PLAN COMMISSION

October 11, 2022

PLAN COMMISSION REPORT

Proposal:	Plan Review – Parking Lot Addition
Description:	Site, landscaping, and related plan review for a proposed addition to the existing parking lot.
Applicant(s):	Chad Gillenwater, Independence Corrugated
Address(es):	525 W. Marquette Ave. (1 st Aldermanic District)
Suggested Motion:	<p>That the Plan Commission approves site and related plans submitted by Chad Gillenwater, Independence Corrugated, for the property at 525 W. Marquette Ave. with the following conditions:</p> <ol style="list-style-type: none">1. That all relevant Code requirements remain in effect.2. That all plans are revised to be consistent within and among all pages.3. That the plans are revised to include details for the asphalt removal and vegetative restoration on the east, including removal of the gravel subbase.4. That the plans are revised to identify all existing and proposed parking stalls. Existing stalls to be removed for restoration purposes shall be labeled.5. That the plans are revised to note current Zoning Code requirements.6. That the plans are revised to include locations and screening for any new mechanical equipment, transformers, a

SITE PLAN & CALCULATIONS

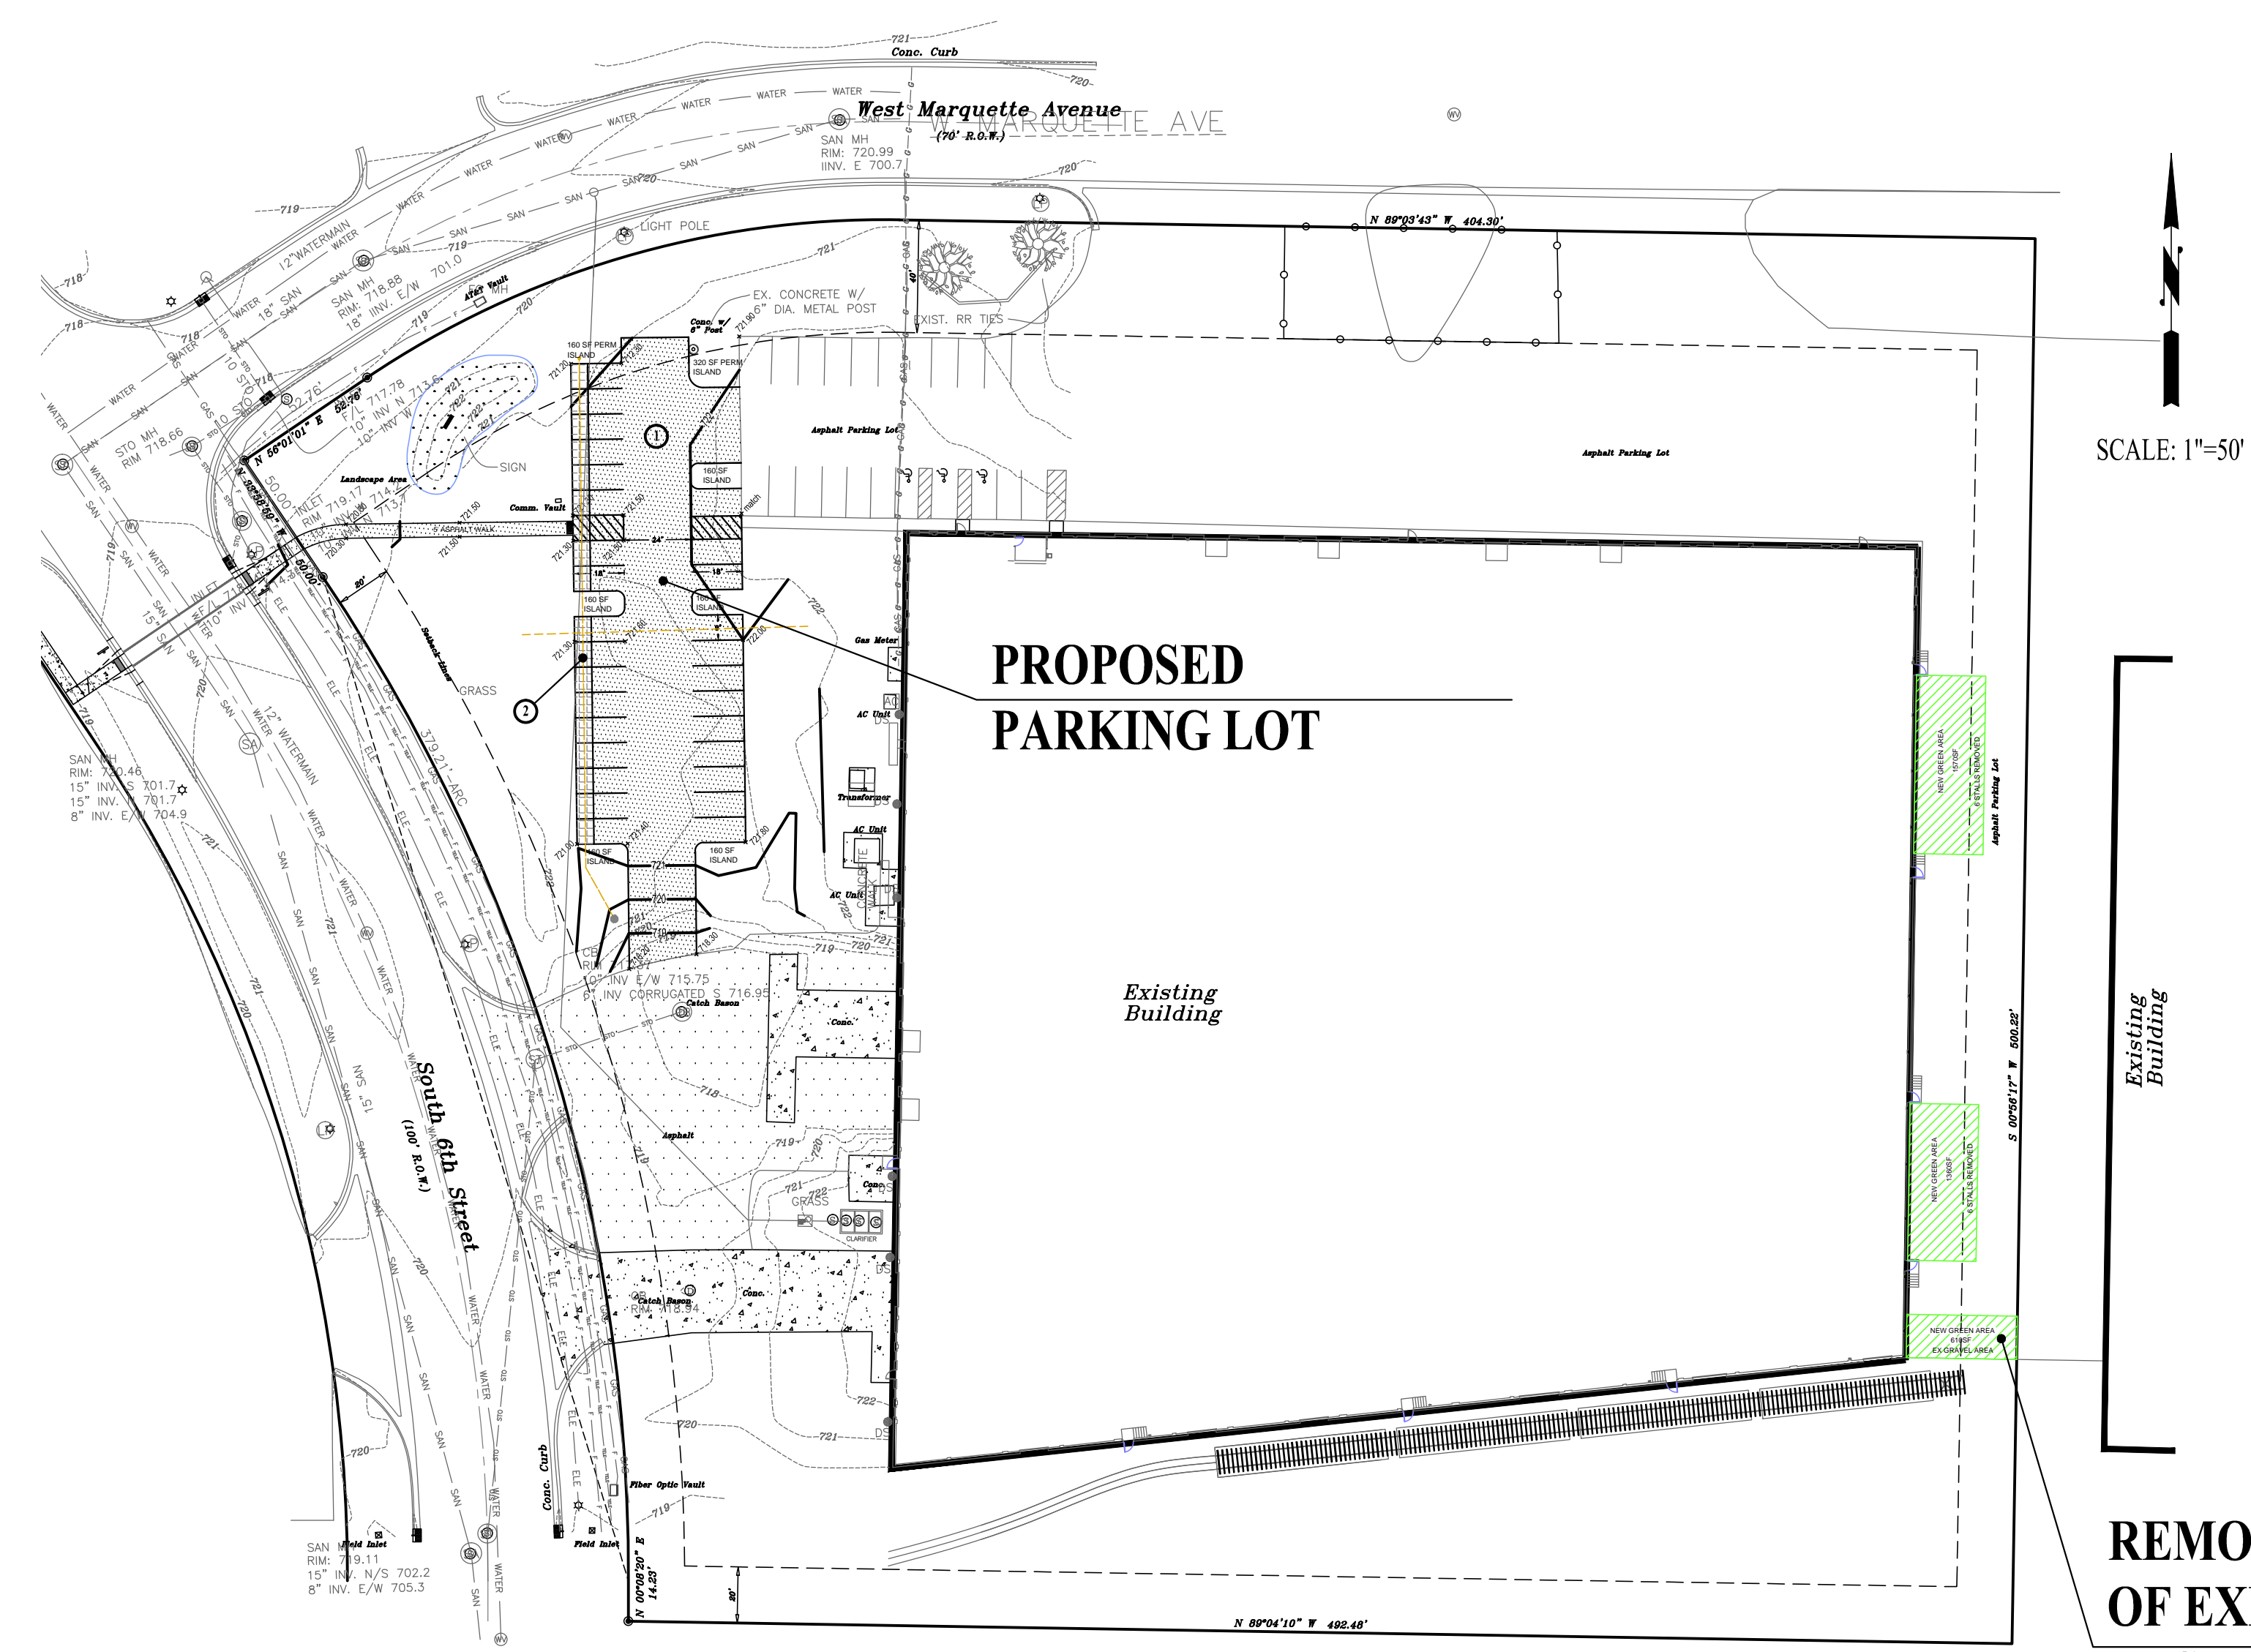
- Civil plans and landscape plans do not match, particularly for the proposed landscape “islands” at the corners of the proposed parking lot (see below for additional comments).
